Minute No. 531
Report - Standing Policy Committee on Infrastructure Renewal and Public Works - September 11, 2007

Item No. 5 **Private Approach - southwest corner of Broadway and Sherbrook Street**
(Fort Rouge-East Fort Garry Ward)
File SC-1(32)

RE: ACCESS TO A PROPOSED PARKING LOT LOCATED AT THE SOUTHWEST CORNER OF BROADWAY AND SHERBROOK STREET

THE CITY OF WINNIPEG PUBLIC WORKS DEPARTMENT TRANSPORTATION ENGINEERING DIVISION	NYGARD INTERNATIONAL # 702 & 704 BROADWAY	PRIVATE APPROACH APPROVAL NO. D-07066
DRAWN BY: J.G. DATE: 07.06.07	SCALE: 1:500	DRAWING NO. A-07066
	APPROVED BY: DATE

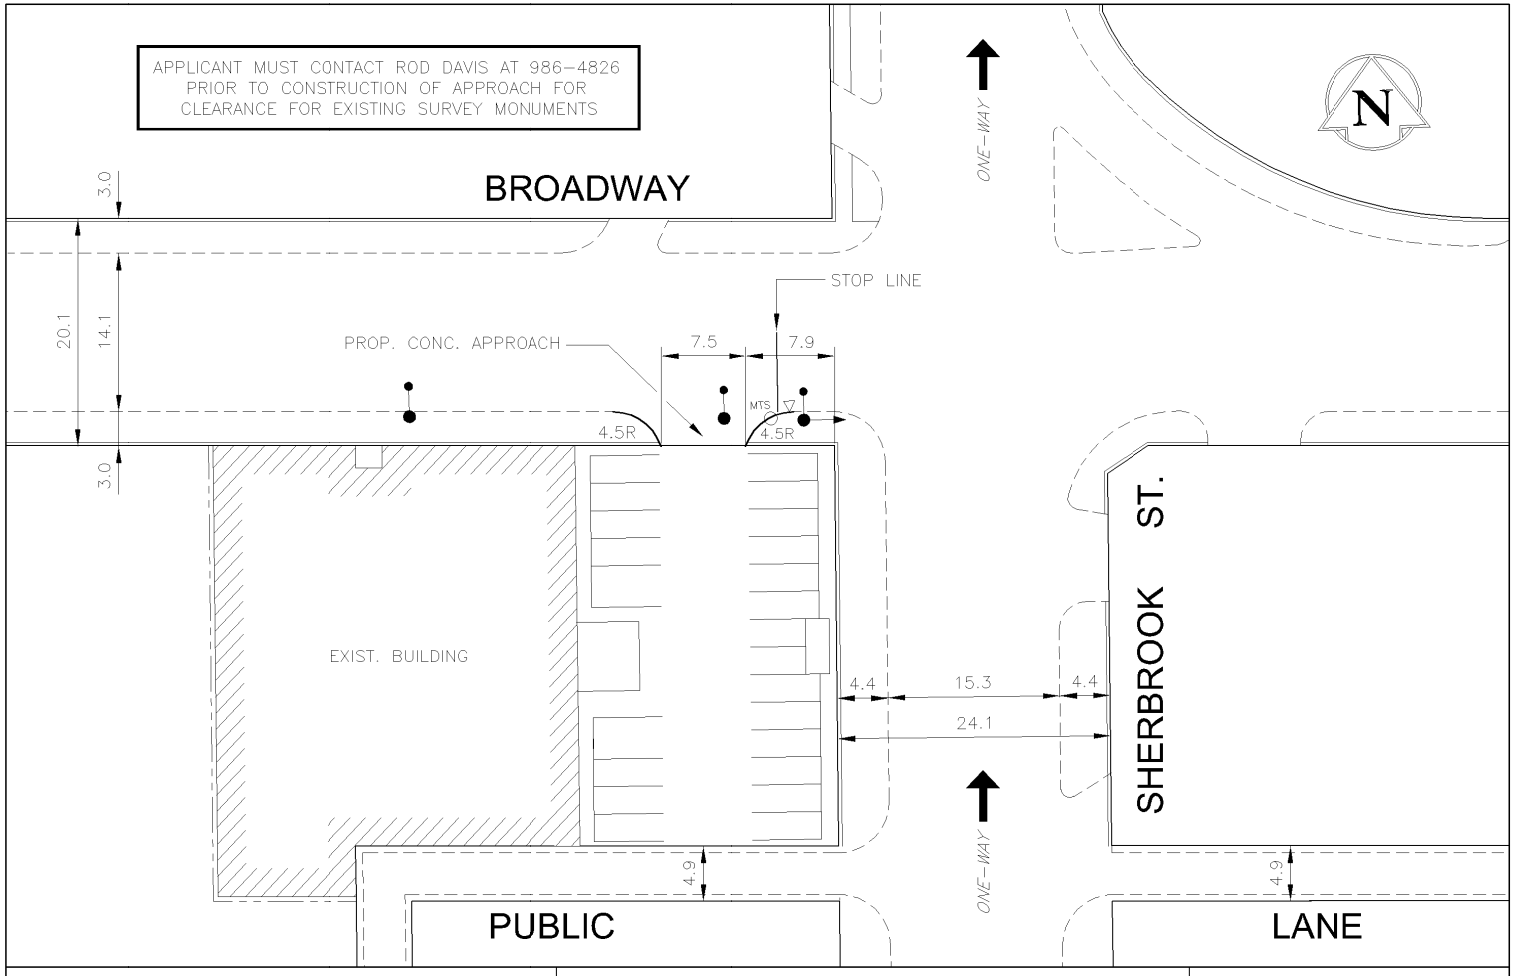
This Department submitted a report for a non-conforming bi-directional private approach on the south side of Broadway to the Standing Policy Committee on Infrastructure Renewal and Public Works for its meeting on July 3, 2007. This Department's report recommended that the Committee *not* approve this non-conforming bi-directional private approach. The Committee laid over this matter at the request of the applicant. A revised plan has been submitted to this Department, which includes an angular "entrance only" private approach on the south side of Broadway, as illustrated on Drawing No. A-07066.

Proposed access to the proposed parking lot will be from a proposed non-conforming angular "entrance only" private approach on the south side of Broadway and the east-west public lane south of Broadway.

The Private Approaches By-law does not permit any private approaches to be constructed on this section of Broadway. However, this Department recommends that the Committee approve this application, as it is not expected that this angular “entrance only” private approach will cause any traffic operating problems on either Broadway or Sherbrook Street.

That the Standing Policy Committee on Infrastructure Renewal and Public Works order that the Private Approaches By-law No. 6546/95 be varied to authorize the construction of a 6.0 metre private approach on the south side of Broadway, 9.0 metres west of Sherbrook Street (as shown on Drawing No. A-07066).
